Access Compliance Report Public Rights-of-Way (Pedestrian Signals)

Signal Type: One Push Button-Non APS Severity Score: BTN 1:N/A BTN 2: N/A No BTN: ADA ID: 84784A562F29 **Overall Compliance: No** N/A

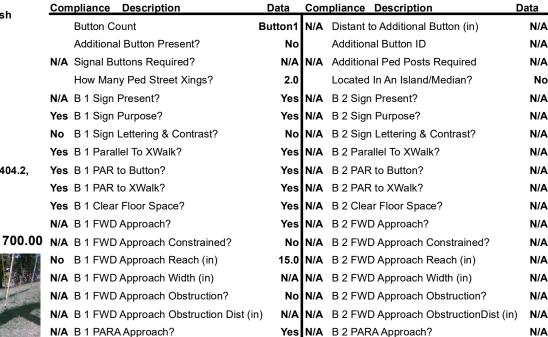
PROW/ADA: R410.6. TMUTCD 4e.08. R404.2. R404.3, R406.2, R404.7.3, R406

Possible Solutions: Replace Signal Push Button With APS Button on New Post. Remove & Replace Sign.
